# CITY OF SAN ANTONIO

Re: Seale 351.25 Acre Tract Subdivision (Amendment)

MDP # 791-B

SEALE 351.25 ACRE TRACT  
MASTER DEVELOPMENT PLAN

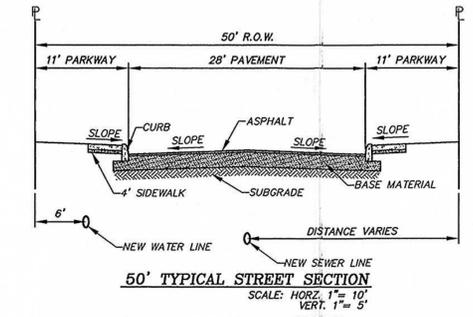
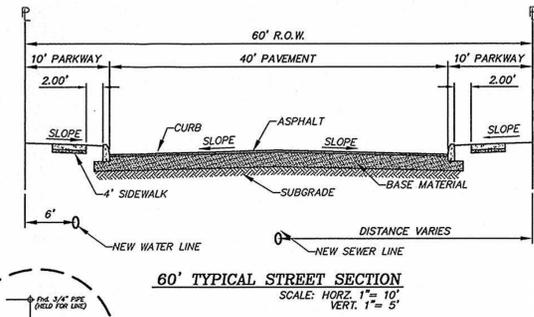
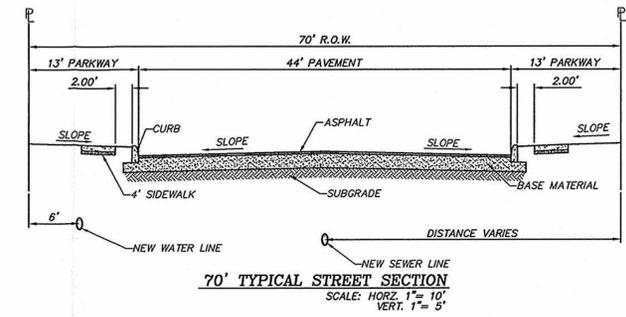
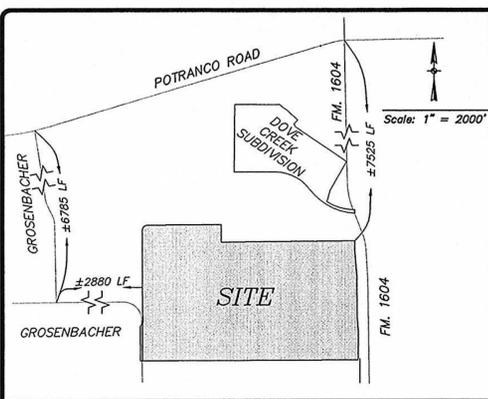
- In consideration of public safety and convenience, excessive grades by reason of topography should be avoided in street layouts and arrangements.
- Any access and R.O.W. issues along State facilities will need to be resolved with the Texas Department of Transportation (TXDOT). For information about these requirements you can contact TXDOT at 615-5814.

- The acceptance of this Master Development Plan # 791B is confined to the boundary limits of the site. Any projection(s) of future roadways outside the boundaries does not infer any set alignment of future roadways. All major arterials and streets shall follow all regulations.

- It should be understood that note 14, 15 on the plan does not waive requirements of UDC section 35-412 that states MDP shall be conformed to in processing any Application for rezoning, Traffic Impact Analysis (TIAs), subdivision plats (minor and major), PUD Plans, and /or Utility Master Plans.

- It should be understood the current alignment of the proposed roadways on the Seale tract does not match the approved MDP #770, Champions Park. All roadways shall be aligned at the time of platting per UDC section 35-506 (e)(2).

- It will be expected that you will plat all of the property depicted in your Master Development Plan (M.D.P.), to include: flood plains, drainage areas and open space.

- Historic Preservation Design and Review Division, Department of Planning and the City Parks and Recreation Department and the applicant of this MDP agree that Padron Hill shall be preserved and protected as a natural area. There is a dedication requirement of 14.0 acres

for the submitted plan. The donation of the hill of approximately 13.65 acres as a natural area precludes the payment of an in lieu of fee and required development, in accordance with Section 35-503 of the UDC. This, in combination with other parkland submitted in the plan, will meet the City's park dedication requirement.

- The Development Services Engineering (TIA) as part of their conditional approval cite the following, on-site improvements, as well as, improvements along the project limits are necessary and shall be provided by the developer at the time of platting for Seale Tract Development, at no cost to the City Of San Antonio:

1. Grosenbacher – The Developer shall dedicate 43 feet of ROW (Ordinance 98282, October 2, 2003 Major Thoroughfare Plan (MTP) from the centerline of Grosenbacher (Secondary Arterial Type A-Unified Development Code (UDC) 35-506, (g),(2)) adjacent to this proposed project. The total length of property frontage is approximately 823.33 feet as indicated by submitted MDP.

2. Construction of an internal east-west collector street system approximately 3800-feet in length. Collector street design parameters consist of 70-feet of ROW and 44-feet of pavement (Table 506-3). The proposed collector street shall have no houses fronting (UDC 35-515, ©,(4)).

3. Construction of an internal north-south Local B Street approximately 1400-feet in length from the end of the proposed collector to the undeveloped property south depicted on the MDP as Milestone Potranco Development, LTD. (UDC Appendix A, Definitions of Local A and Local B).

4. All Roadways shall conform to UDC 35-506 (c), (1), Table 506-1: Functional Classification System Description.
  5. All proposed driveways shall follow UDC 35-506, (r) Access and Driveways.

It should be understood that the submitted TIA concurrent with the proposed Seale Tract MDP is a conceptual plan and therefore this document does not represent an approval for the internal street plan. All streets shall follow UDC 35-506 and the street network shall be planned in order to provide safe and efficient movement of traffic to and from, within and past, the proposed development, while minimizing the impact to non-site trips. UDC 35-506 will be implemented at the time of platting.

The proposed Seale Tract Collector Street at build out will carry an estimated 13,530 Average Daily Trips (ADT). The Seale Tract Development will have additional access to Grosenbacher/Marbach (Secondary Arterial, Type A 86' of ROW), Loop 1604, and to the undeveloped property to the south that will construct Marbach Road (See Attachment A). There is no timeline for the extension of Marbach Road west of Loop 1604 to Grsenbacher.

It is important to note that the mitigation measure (traffic signal at Loop 1604 and access collector) proposed in this TIA is not valid. TxDOT is currently improving Loop 1604 in the vicinity of the Seale Tract. The ultimate construction improvements to Loop 1604 propose grade separations at Marbach Road and Dove Canyon. TxDOT is in the midst of implementing the first phase of the ultimate improvements for Loop 1604. This interim phase will construct a four-lane divided facility in the vicinity of this development and will include a "north to south" turnaround at Dove Canyon. Northbound vehicles wishing to utilize the proposed Collector Street for Seale Tract will utilize this turnaround, as all access to and from, Loop 1604 for the Seale Tract MDP will be a right in and right out movement.

It should also be noted that the submitted Level 3 TIA did not project traffic to Cagnon Road in the northbound and southbound direction.
